March 28, 2018

RE: Ballek Subdivision - Four Meadows Farm – 5222 Mt. Philo Road

This response is to address the wastewater review comments made on 03/09/18. The plans have been modified to reflect changes associated with these comments. The modified plans are attached. The comments and responses are as follows:

**C1-02**

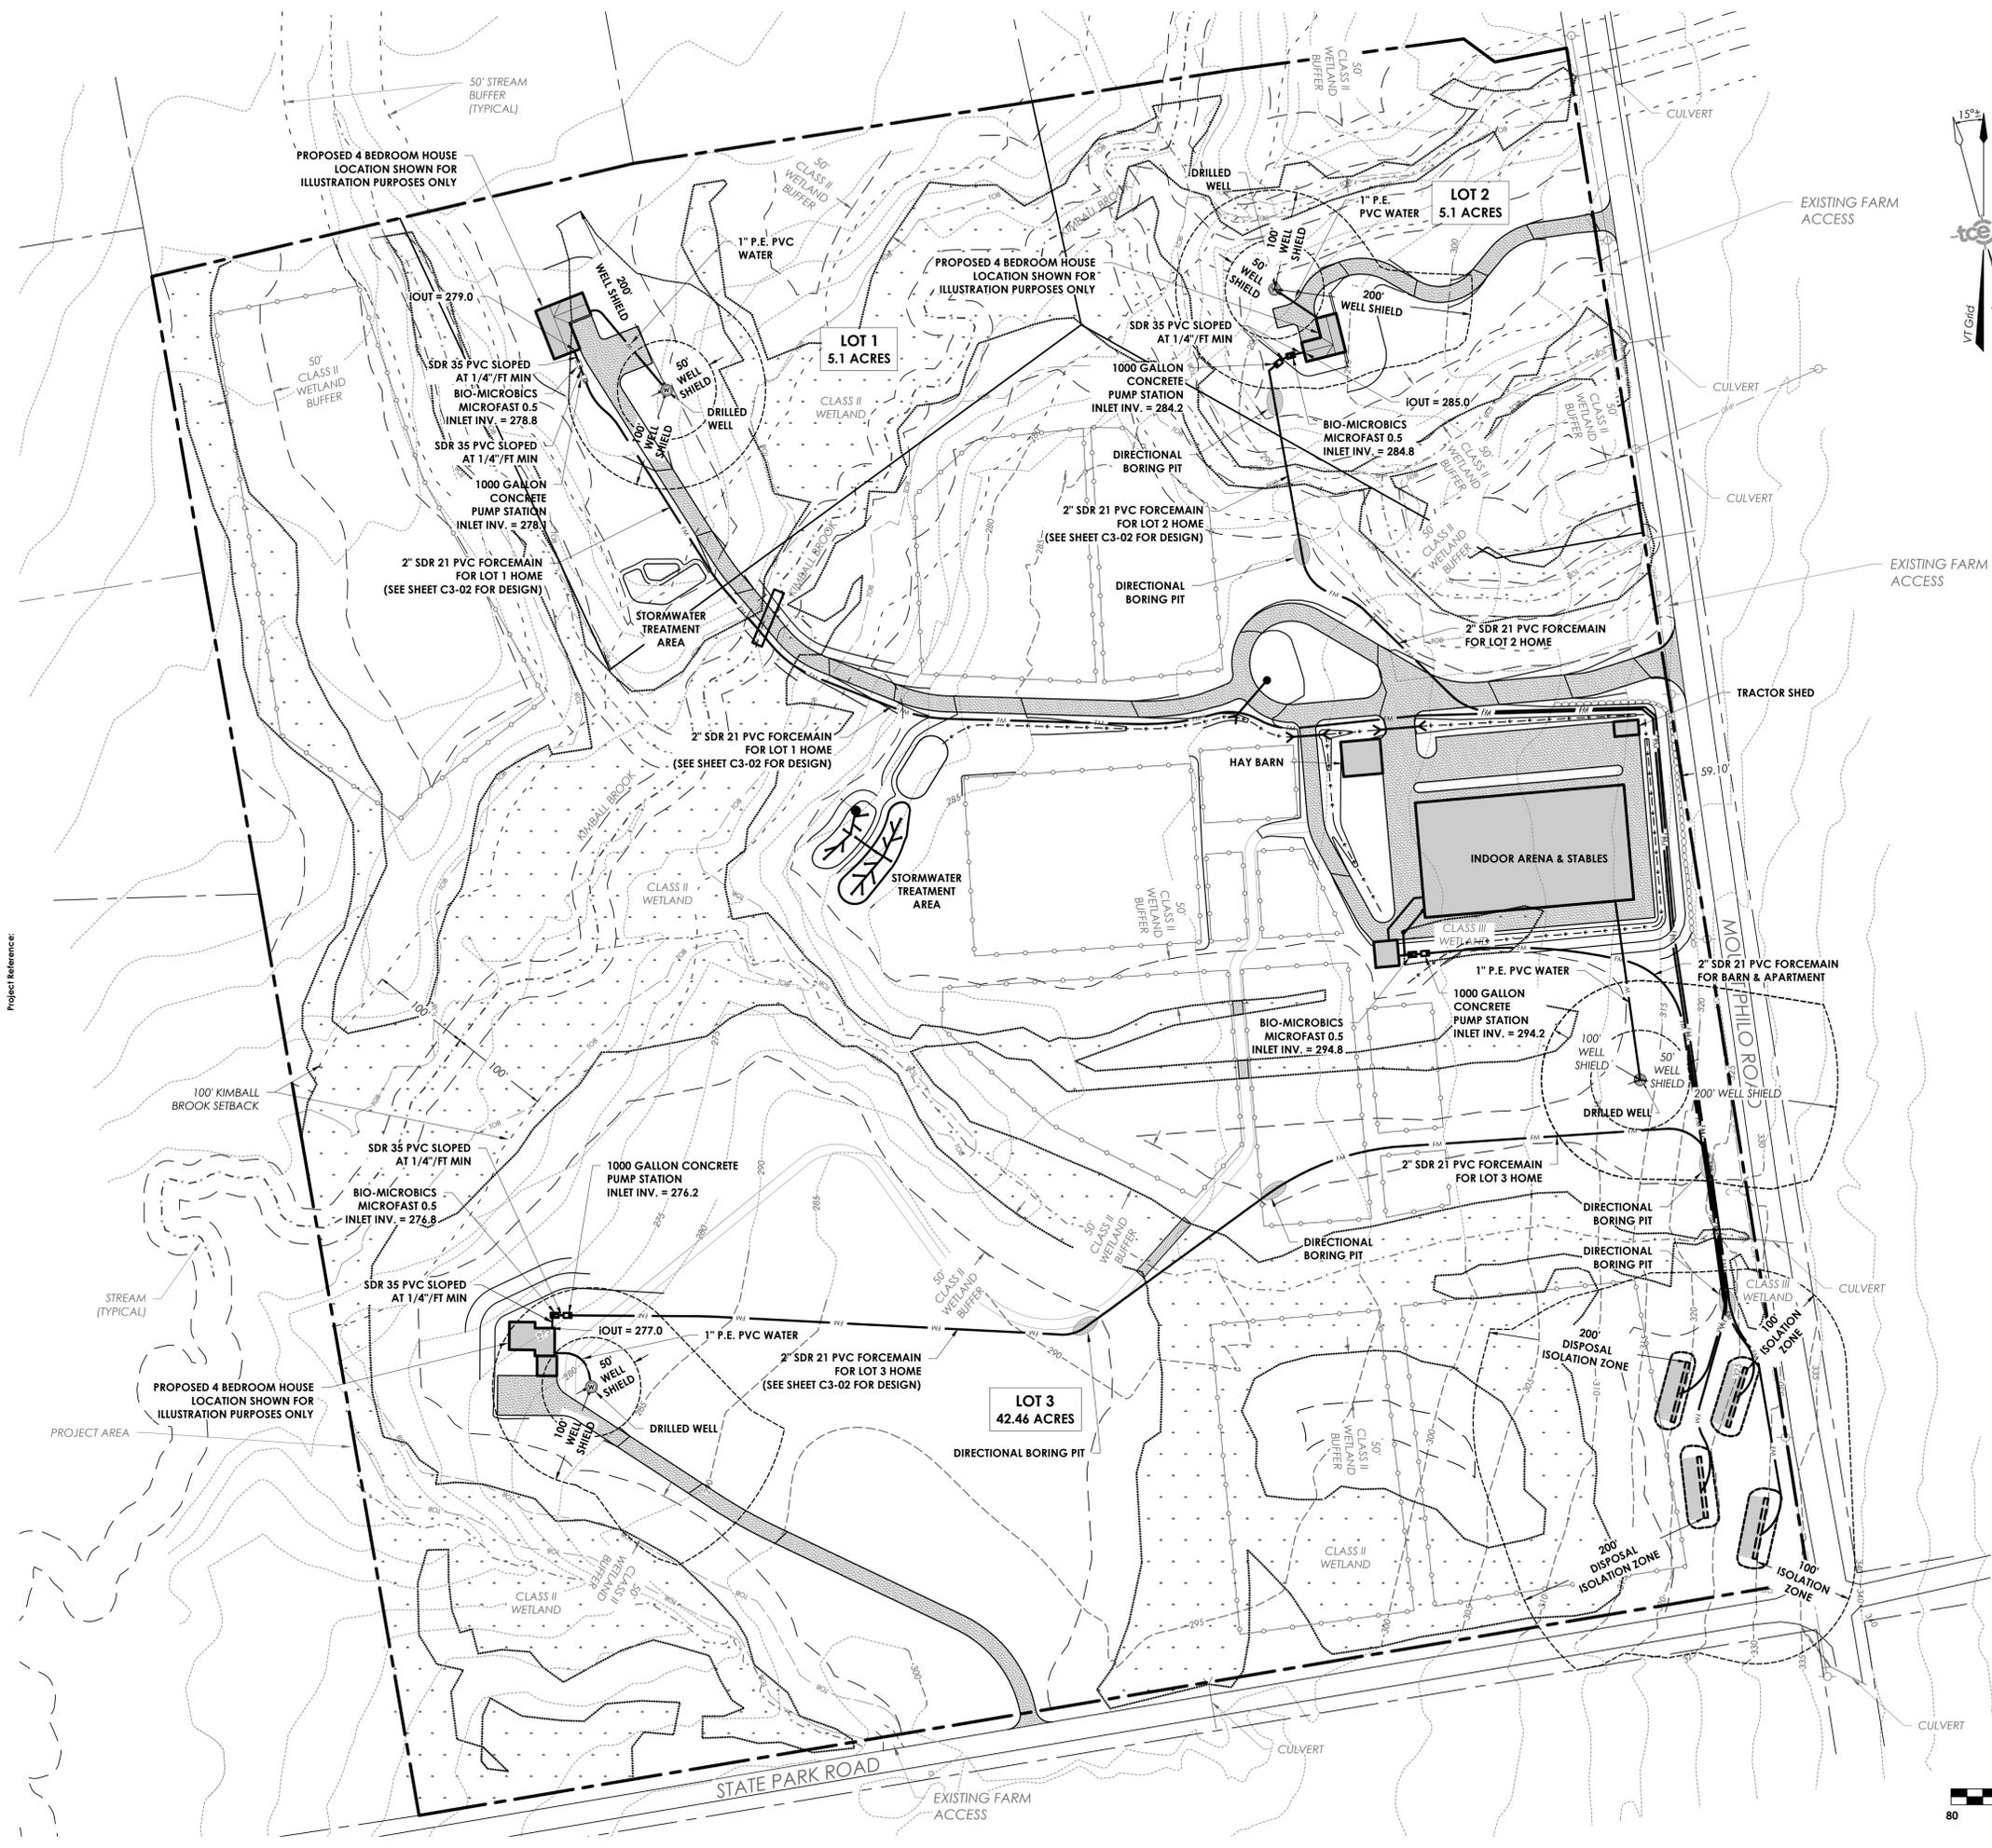
4. Test pits 11 and 12 are shown in two different places: in the proposed ww system area in the southwest corner of the property (Sheet C3-02), and near the proposed house site on Lot 2 (Sheet C1-02) in the northeast corner.

Plan Sheet C3-02 correctly showed the location of test pits 11 & 12 in the southwest corner of the property. The test pits located in the northeast corner of lot 2, on Sheet C1-02, were incorrectly numbered. These test pits have been renumbered 11A & 12A. Plan Sheet C1-02, Existing Conditions Plan, has been updated accordingly.
